Technical Service Bulletin

46 Brake/Parking brake - not released after stationary period

46 23 54 2071304/2 December 11, 2023. Supersedes Technical Service Bulletin Group 46 number 23-47 dated September 7, 2023 for reasons listed below.

Model(s)	Year	VIN Range	Vehicle-Specific Equipment
Q4 e-tron, and Q4 Sportback e-tron	2022 – 2023	All	Not Applicable

Figure 1: Gasket (2) between brake carrier (3) and wheel bearing housing (1).

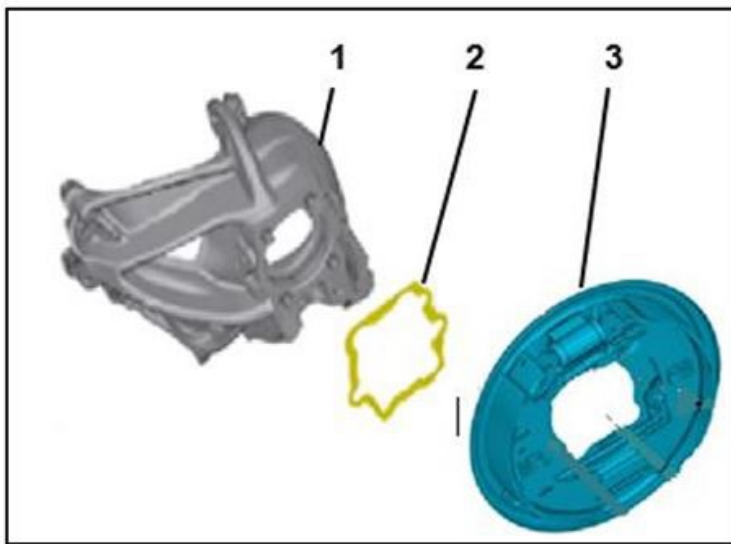
Moisture gets into the rear brakes. This can result in the rear brake shoe seizing due to corrosion or freezing to the brake drum.

Gasket installed in production starting: May, 2023.

1. Perform conditioning of brakes to clean friction faces.
2. Take photos of rear brakes and upload to DOC-IT.
3. Install gasket between brake carrier and rear (left/right) wheel bearing housing (item 2, Figure 1).
4. Check rear brakes and (if required) replace brake shoes and/or brake drums.
5. Inform the Customer.
